## DART SERVICE INSTRUCTION

TO AMEND INSTALLATION INSTRUCTIONS IIN-D412-742-2 REV.A OR LATER APPROVED REVISIONS AND INSTRUCTIONS FOR CONTINUED AIRWORTHINESS ICA-D412-742-2 REV.0 OR LATER APPROVED REVISIONS

DRAWING NO. **DSI 9900**

TITLE CABLE GUARD SCALE

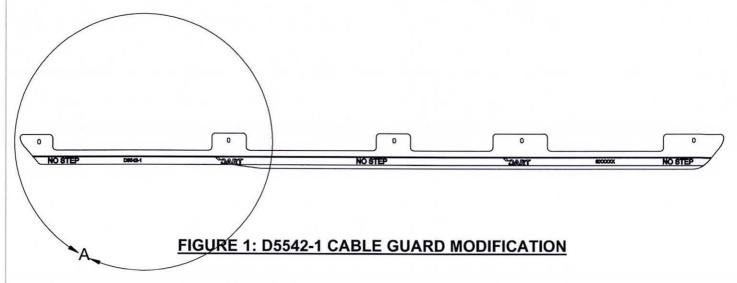
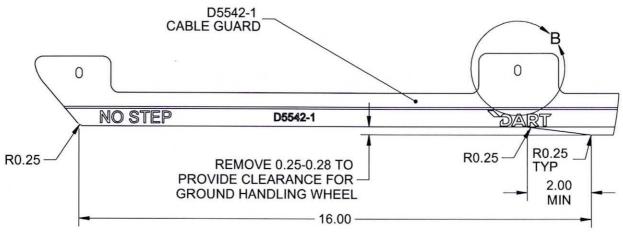
It has come to Dart's attention that the Dart D412-742-028 Cable Guard may interfere with the use of the ground handling wheels. The purpose of this Dart Service Instruction (DSI) is to allow customers to modify/trim the D5542-1 Cable Guard that is installed as part of the D412-742-028 Cable Guard Kit to prevent this interference.

- 2.1 Remove the D5542-1 Cable Guard that is installed as part of the D412-742-028 Cable Guard Kit by removing the AN3C7A Bolts used to attach the D5542-1 Cable Guard to the D5546-1/-3/-5 Brackets.
- 2.2 Modify the D5542-1 Cable Guard by removing the Material shown in Detail A of Figure 1.
- 2.3 If additional clearance is required, it is acceptable to remove material from the tabs of the D5542-1 Cable Guard and slot the holes as shown in Detail B of Figure 1.
- 2.4 Reinstall the modified D5542-1 Cable Guard on the D5546-1/-3/-5 brackets using gty (5) AN3C7A Bolts and associated hardware. Torque bolts 20-25 in-lb (2.2-2.8 N-m).
- 2.5 Make an entry into the aircraft logbook to indicate that the D412-742-028 Cable Guard was modified per DSI 9900.

# -0.194R0.25

ORIGINAL HOLE

0.13 MAX
